Our ref: STH09/01787/44
Contact: Hayley Sarvanandan 4221 2423
Your ref: Land Use Plan

18 November 2019

LAND USE PLAN – LOT 7 DP259137 2514 ILLAWARRA HIGHWAY CALDERWOOD – PROPOSED REZONING AND ACCESS

Concept Subdivision Plan

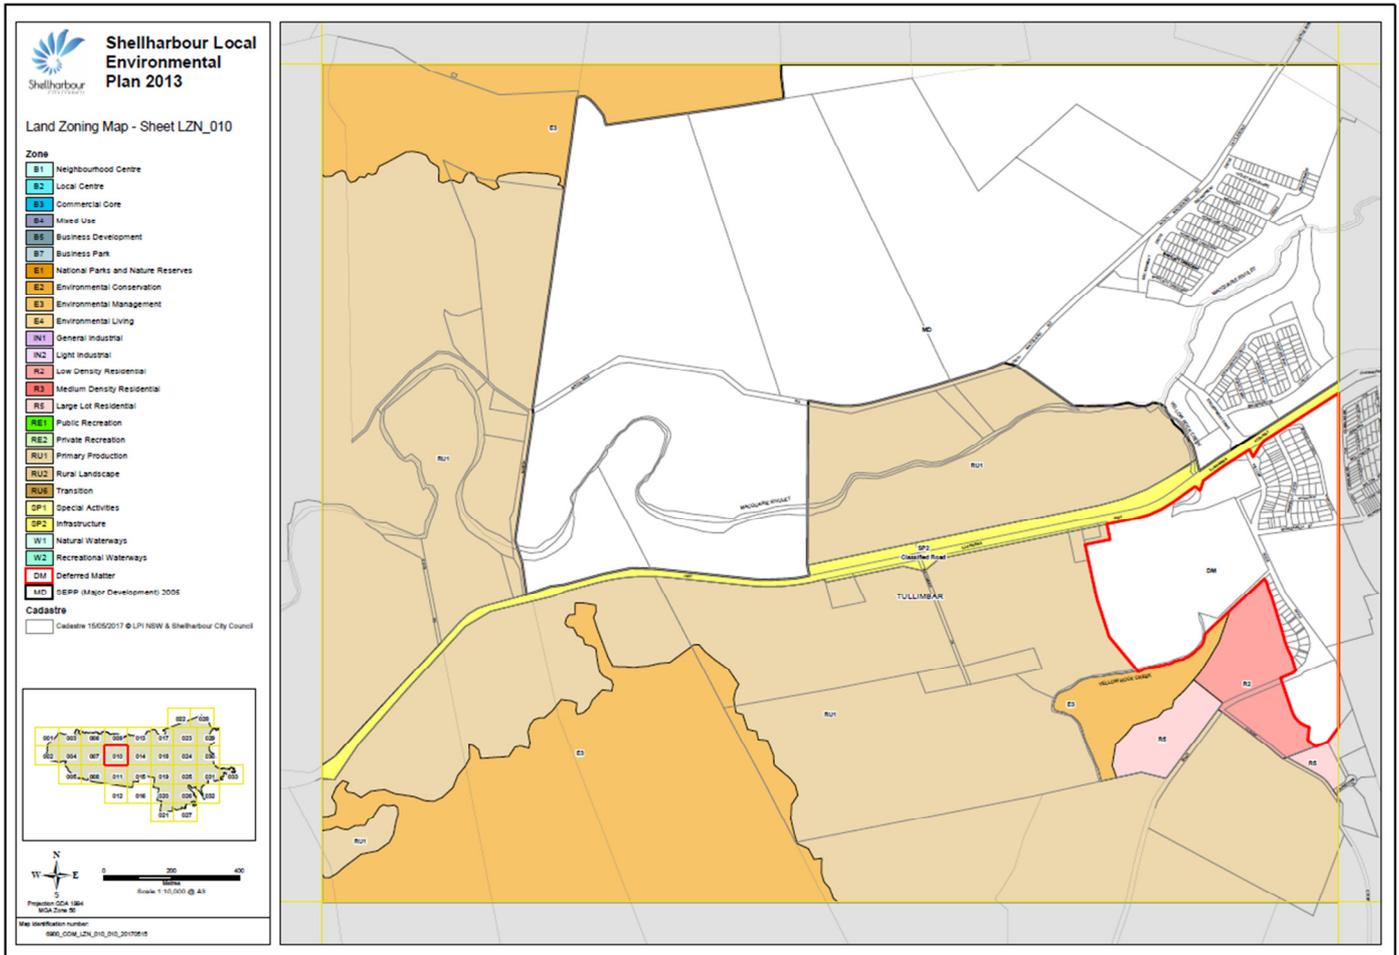
- The indicative layout sketch provided for a future subdivision on the land (Attachment 2) shows residential lots encroaching on this land. This is not acceptable. Please note, Section 26 of the Roads Act, 1993 states that there must not be any constructions on land affected by road widening orders and consent may not be given with respect to a classified road except with the concurrence of RMS. RMS believes the SP2 zoning could potentially help facilitate road upgrades in the future therefore does not support removal of the widening.
- With reference to the email dated 29th October 2019 regarding a similar acquisition over the properties to the east and west of the subject site, RMS can confirm that although the SP2 zoning has been removed the road widening order is still in place as shown in Attachment 4.

- RMS is willing to consider the proposed roundabout treatment for the intersection of Illawarra Highway and Tullimbar Lane. The proposal would need to be supported by a traffic analysis including modelling and a concept design which included details of the works proposed to support the change in speed zone required to allow a roundabout.

- Electronic copies of modelling files need to be provided to RMS for review
 - The concept needs to be compliant with Austroads Guide to Road Design, including demonstrating relevant sight distances are available and demonstrating the design can accommodate the swept paths of the largest vehicles likely to undertake each movement.
 - The concept design needs to show property boundaries to demonstrate the works can be constructed within the road reserve. The concept design also needs to detail the suite of measures proposed on this stretch of the Illawarra Highway to support the change in speed zone required to allow a roundabout (i.e. kerb and gutter, street lighting etc).
- RMS believes the planning proposal would need to ensure there is future connectivity to the adjacent lot (to the west) to preserve the functionality of the Illawarra Highway (i.e. minimise the number of accesses).
